INSTRUCTION BULLETIN

No. 340314
Machine: Litter Hawk t
Published: 6-99/00
System: SWEEPING

Installation instructions for kit number 382633

This kit contains the parts needed to install hood prop rod brace screws on the Litter Hawk™ model vacuum.

FIG. 1 - HOOD SUPPORT KIT INSTALLATION

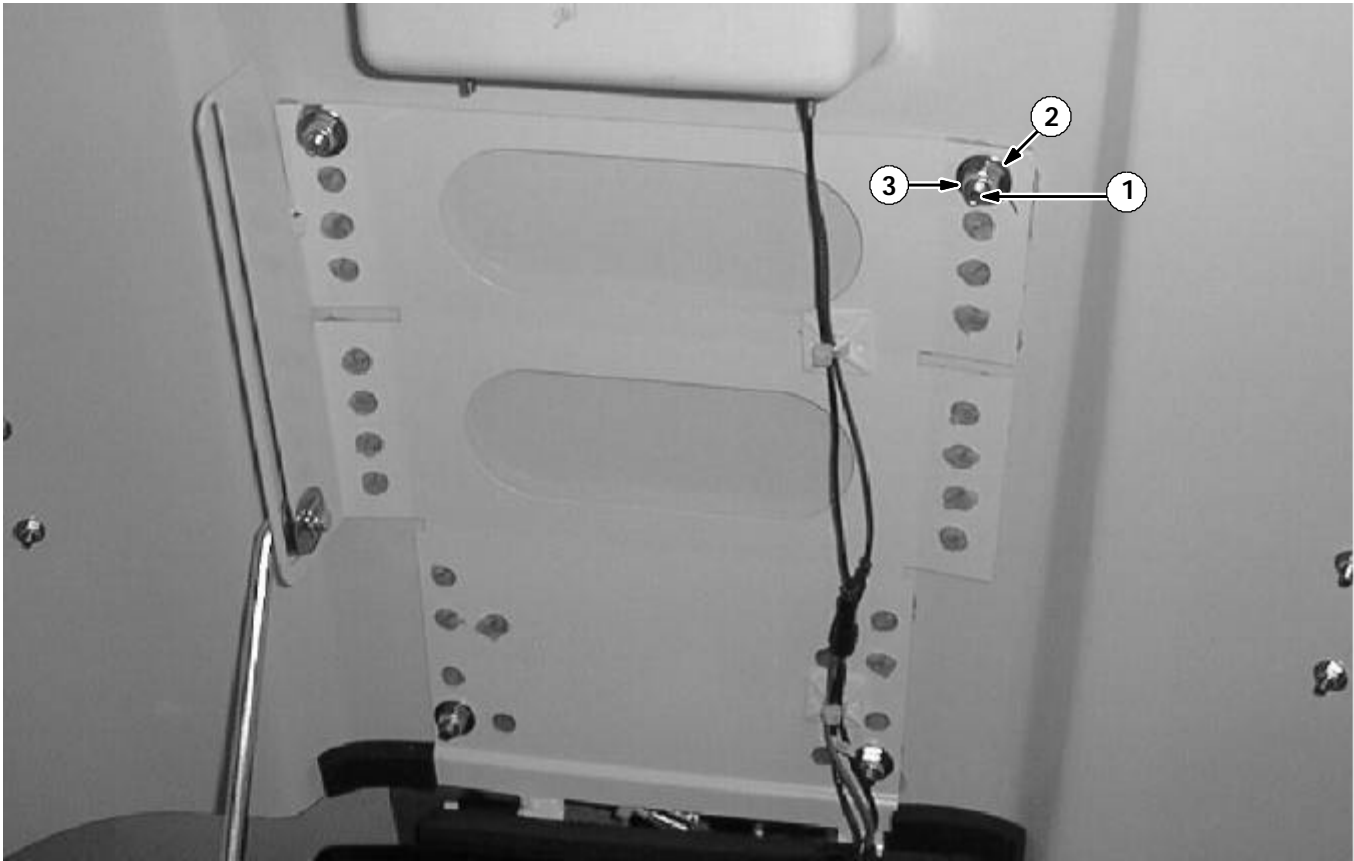
1. Open cover assembly, and engage prop rod.
2. Using hood prop rod brace as a template, mark and drill two 9.5 mm (3/8 in) holes in the two top holes of the hood support brace.
3. Install screws (1), washers (2) and nuts (3) similar to the mounting hardware already holding the support brace.
4. Release the prop rod, and lower the hood.
